ADDENDUM NO. 1 - OUTLINE AND SUMMARY INFORMATION

Project Name: Leon Johnson Redundant Heat Pump Module

PPA No.: 19-0042

Date: November 3, 2021

SEVENTH AND
EIGHT FLOOR
MECHANICAL
PLANS

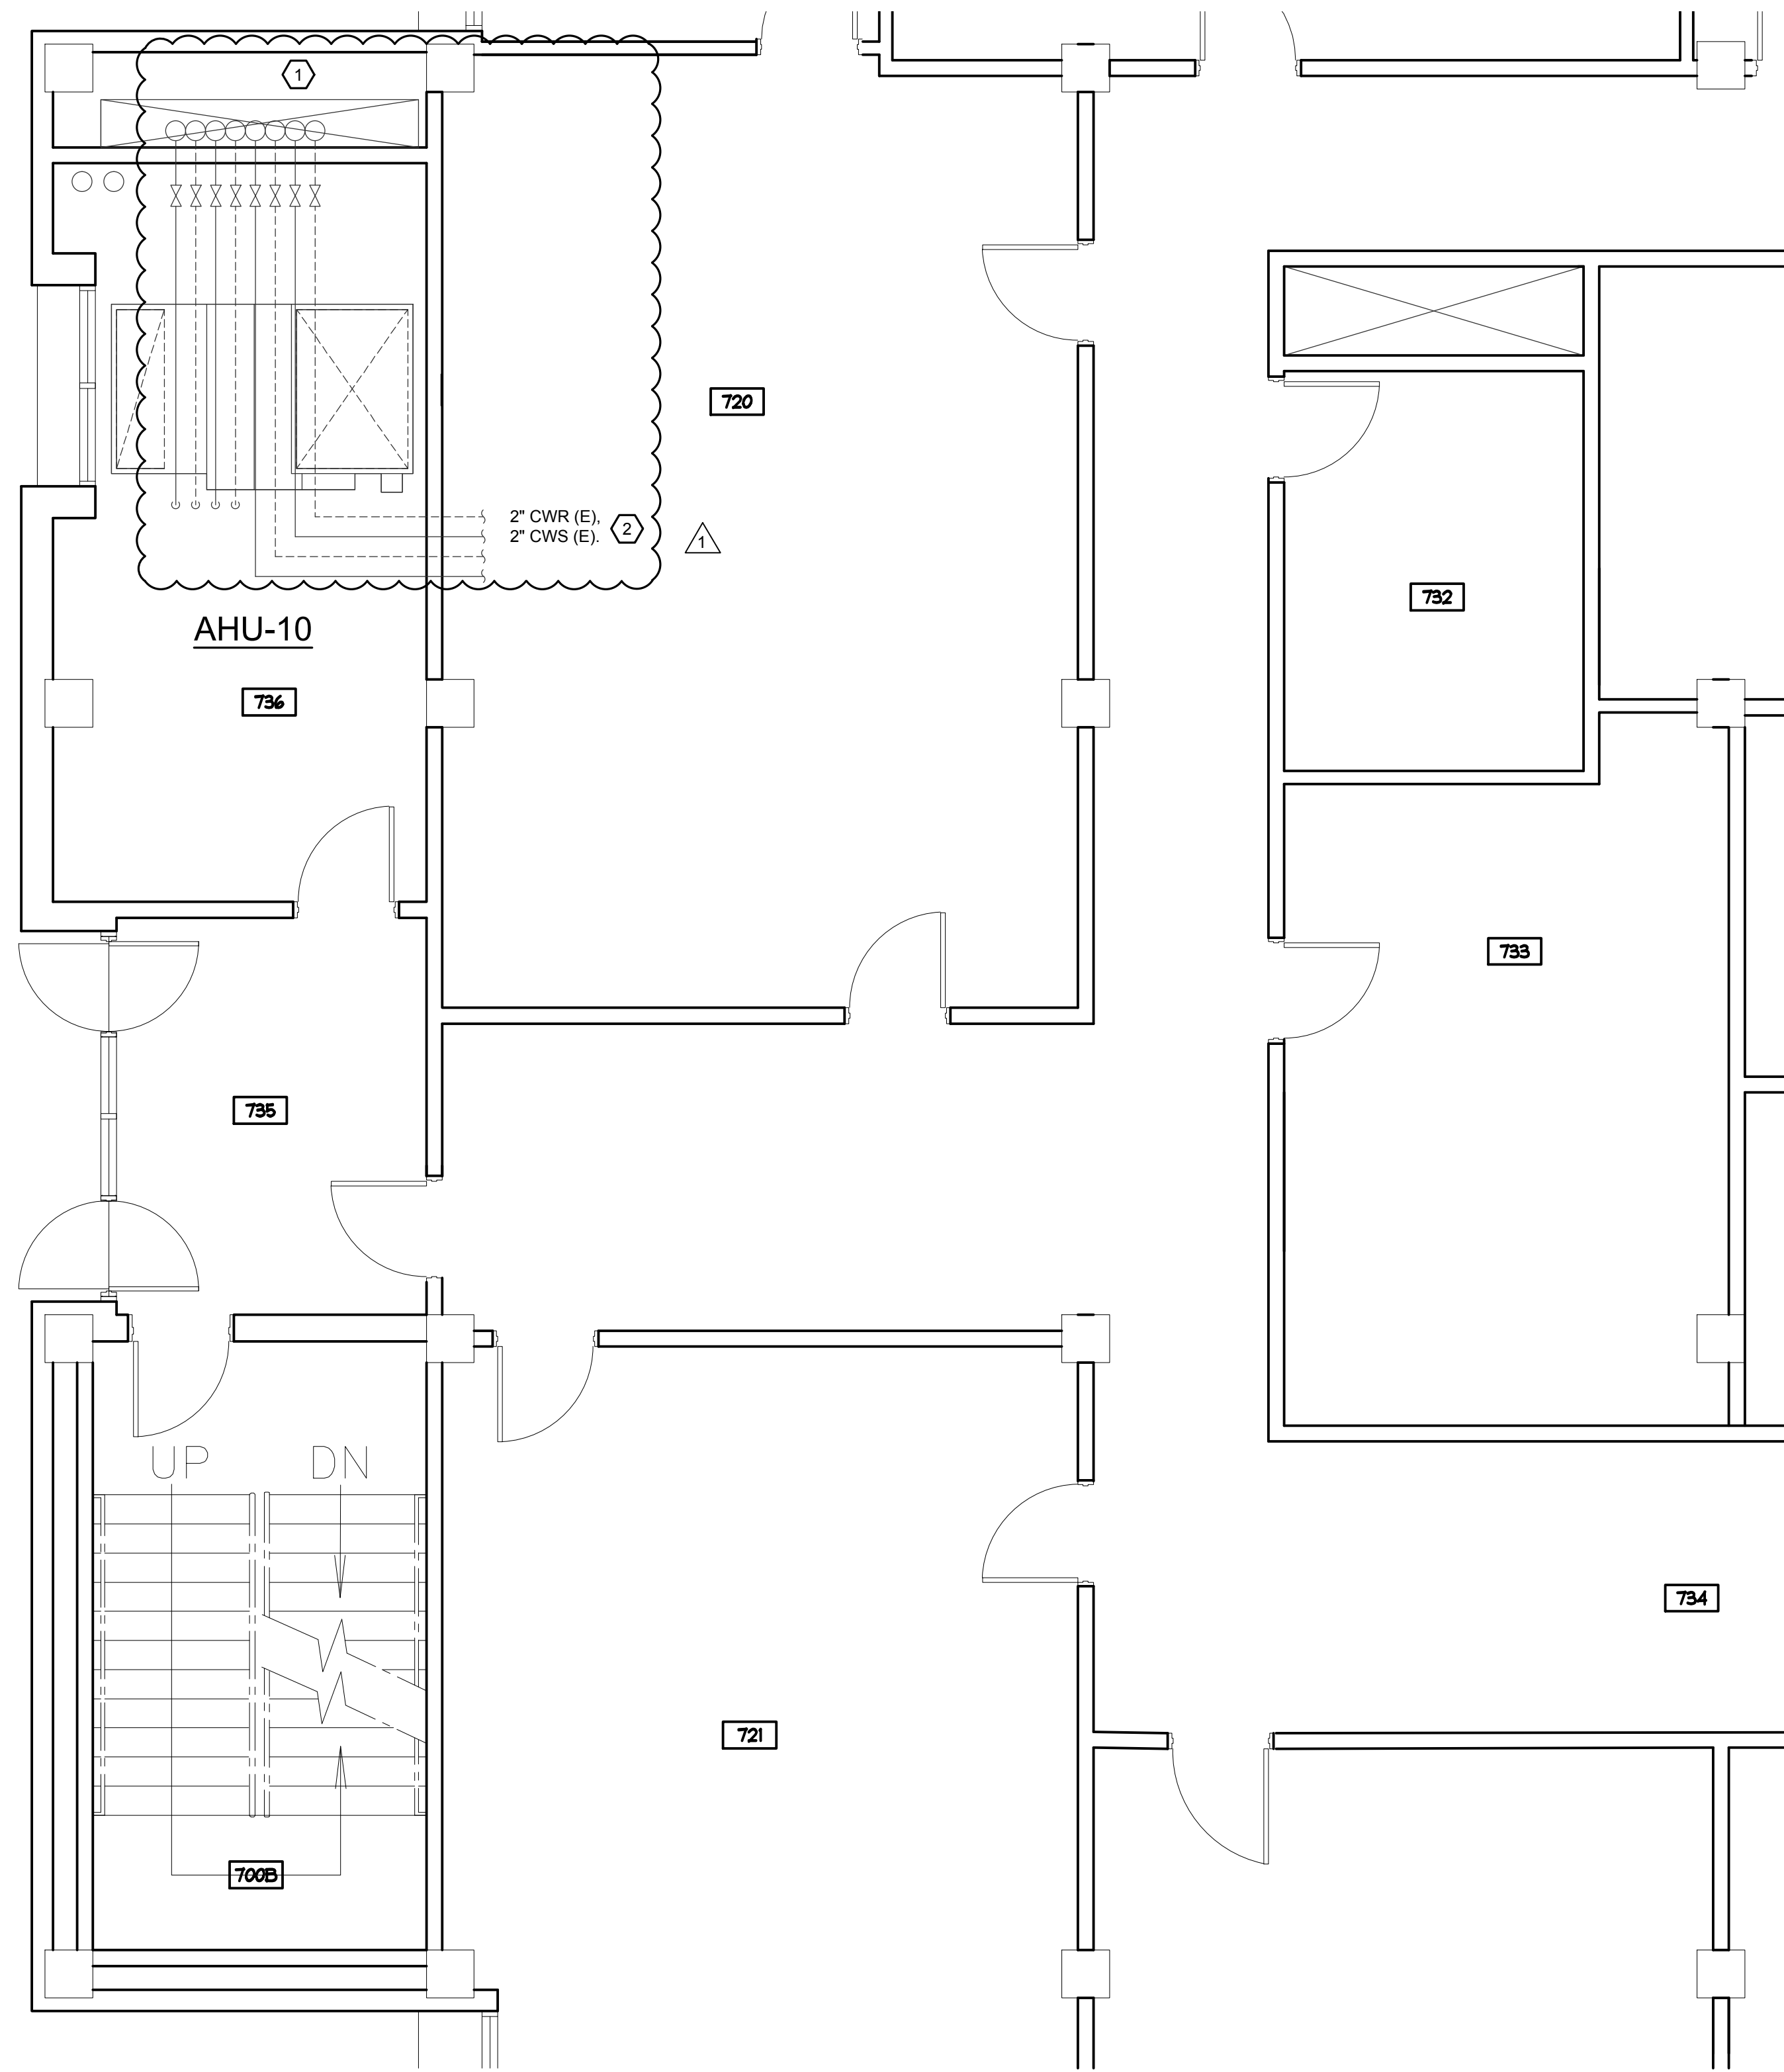
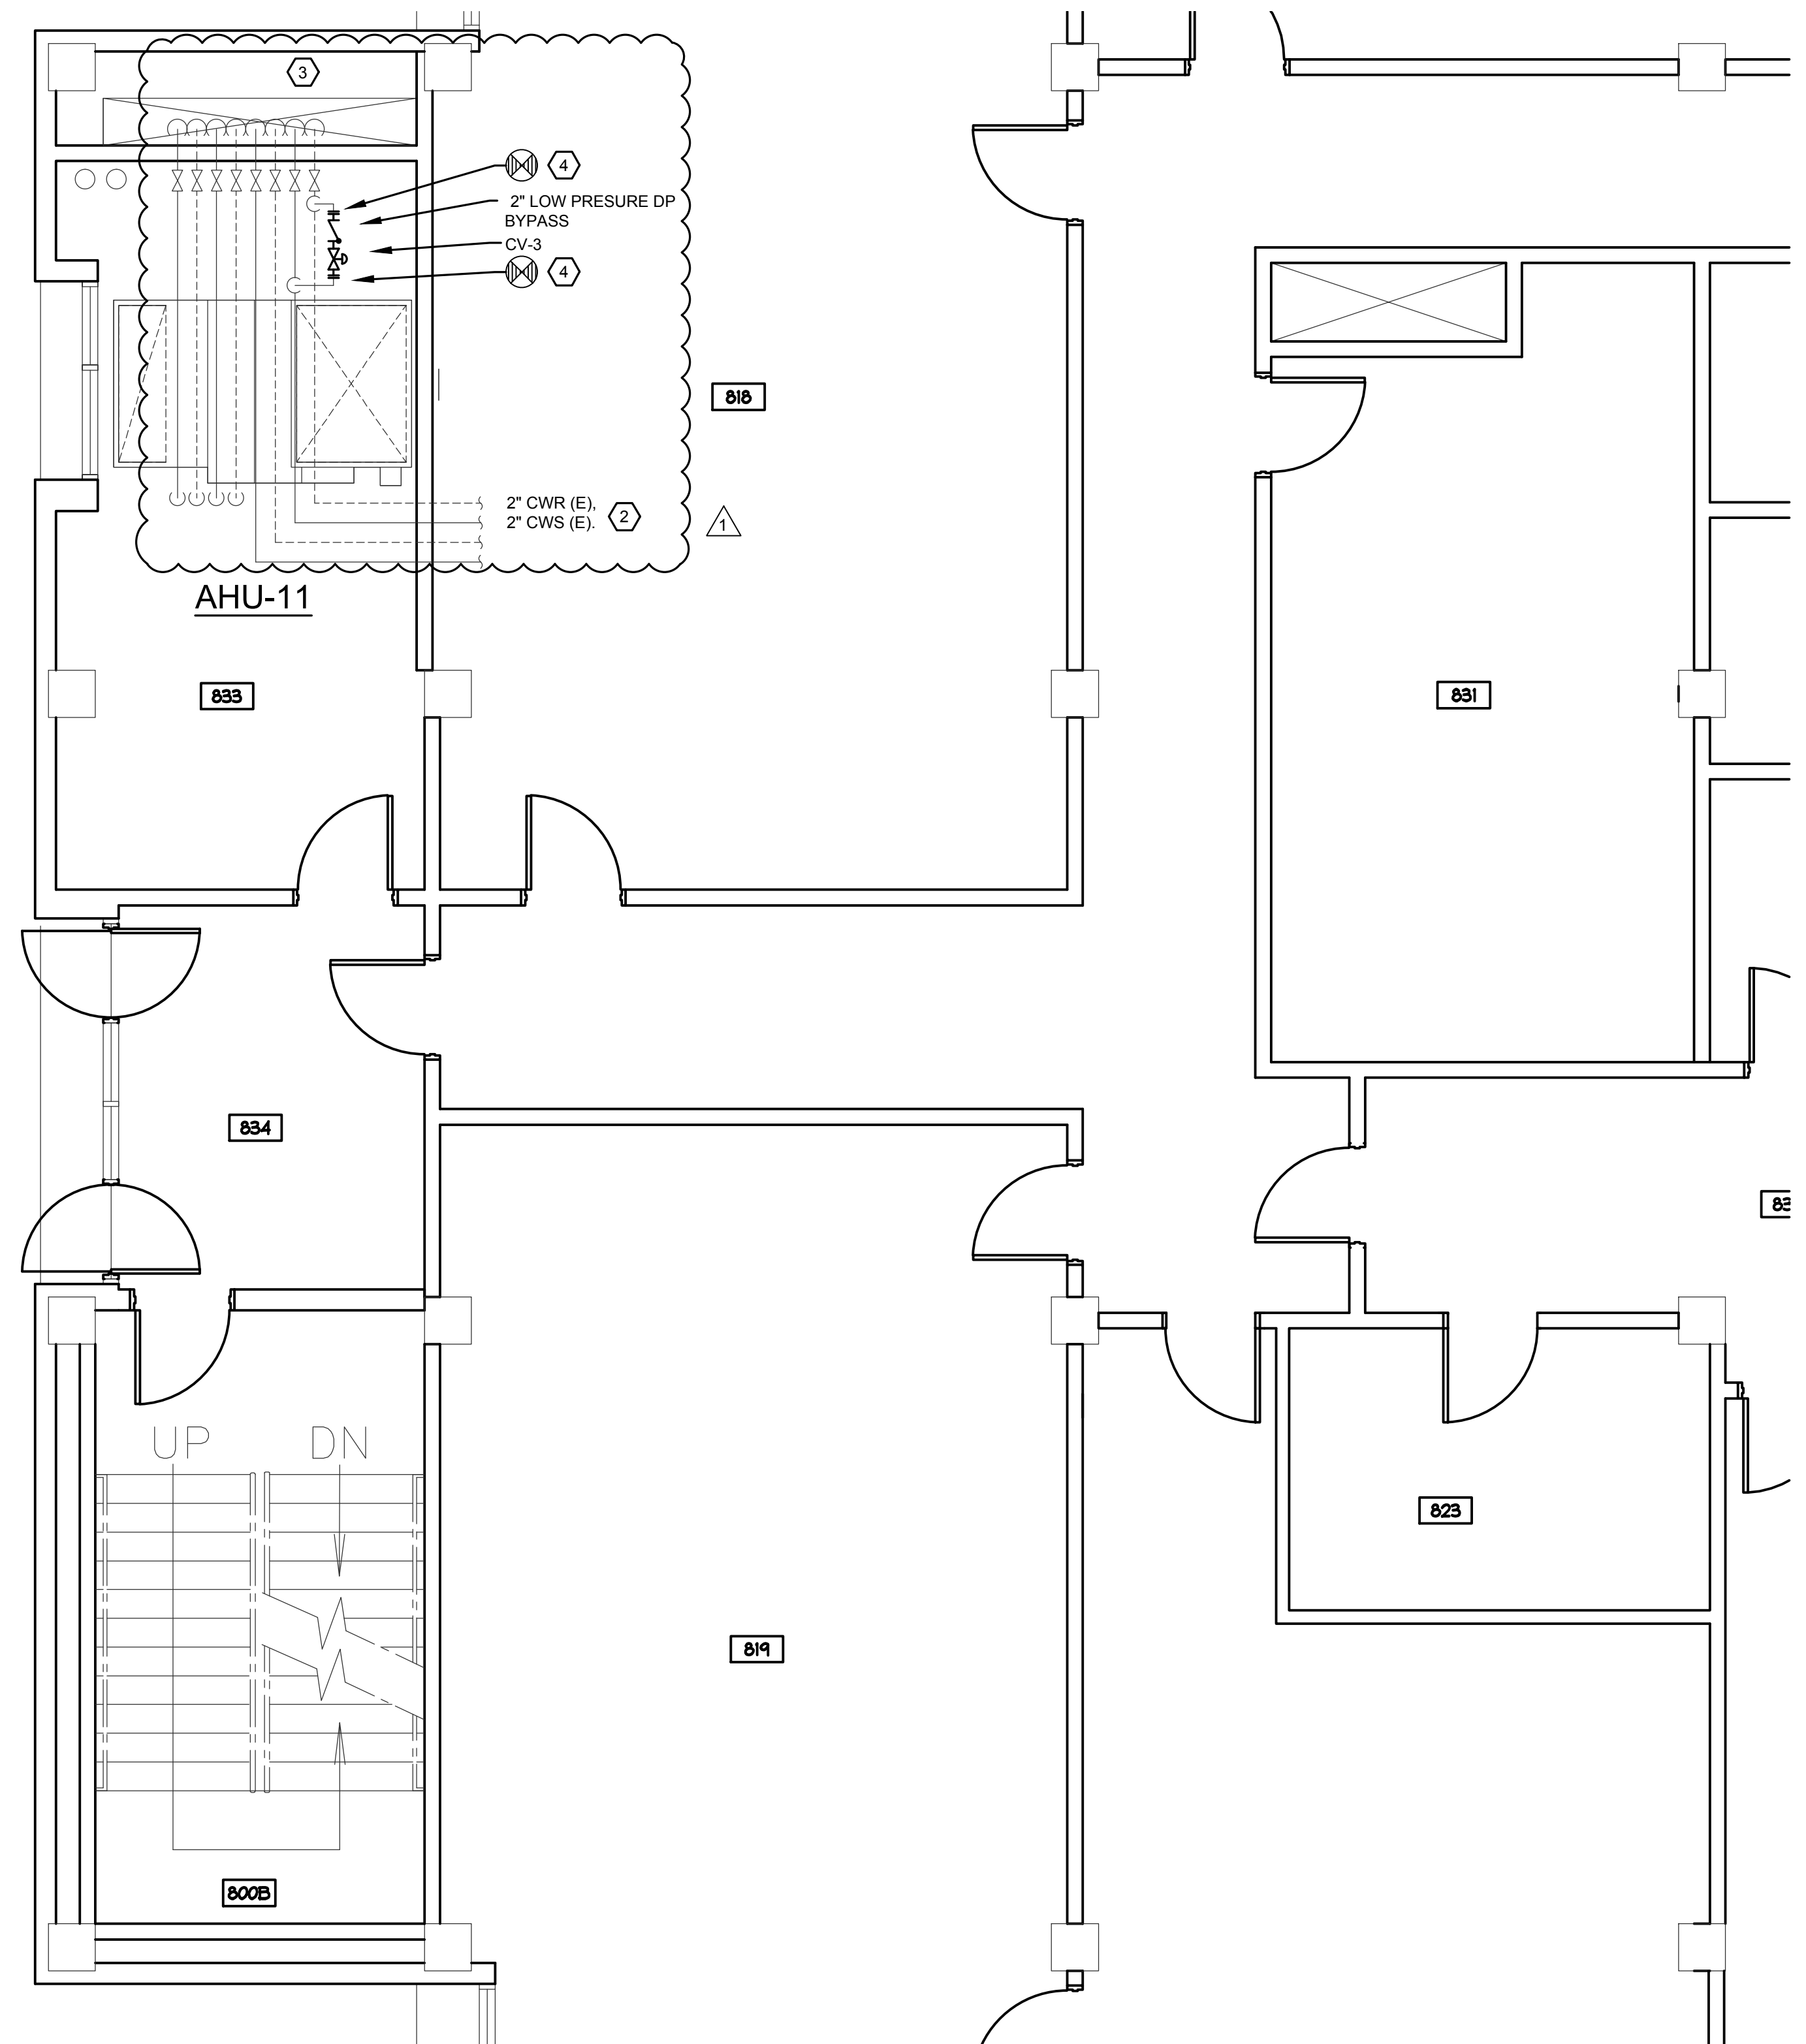
- SHEET NOTES
- 1 EXISTING 3" CWS AND CWR RISERS DOWN AND 2" CWS AND RETURN RISERS UP TO REMAIN.
 - 2 EXISTING 2" CWS AND CWR BRANCH MAINS TO REMAIN.
 - 3 EXISTING 2" CWS AND CWR RISERS DOWN TO REMAIN.
 - 4 REMOVE EXISTING MANUAL BALANCING VALVE, PROVIDE DP CONTROL VALVE AND CHECK VALVE, RECONNECT PIPING. PROVIDE SEPERATE CONTROL CONDUIT AND WIRING FROM THE 8TH FLOOR MECHANICAL ROOM TO THE CONTROLLER IN THE BASEMENT MECHANICAL ROOM. WIRING OF CONTROLS FOR THE BYPASS VALVES, DIFFERENTIAL PRESSURE SENSORS AND CHILLED WATER PUMP VFD'S TO BE TO A SINGLE CONTROLLER TO AVOID NETWORK LAG TIME.

- SHEET NOTES
- 1 EXISTING 3" CWS AND CWR RISERS DOWN AND 2" CWS AND RETURN RISERS UP TO REMAIN.
 - 2 EXISTING 2" CWS AND CWR BRANCH MAINS TO REMAIN.
 - 3 EXISTING 2" CWS AND CWR RISERS DOWN TO REMAIN.
 - 4 REMOVE EXISTING MANUAL BALANCING VALVE, PROVIDE DP CONTROL VALVE AND CHECK VALVE, RECONNECT PIPING. PROVIDE SEPERATE CONTROL CONDUIT AND WIRING FROM THE 8TH FLOOR MECHANICAL ROOM TO THE CONTROLLER IN THE BASEMENT MECHANICAL ROOM. WIRING OF CONTROLS FOR THE BYPASS VALVES, DIFFERENTIAL PRESSURE SENSORS AND CHILLED WATER PUMP VFD'S TO BE TO A SINGLE CONTROLLER TO AVOID NETWORK LAG TIME.
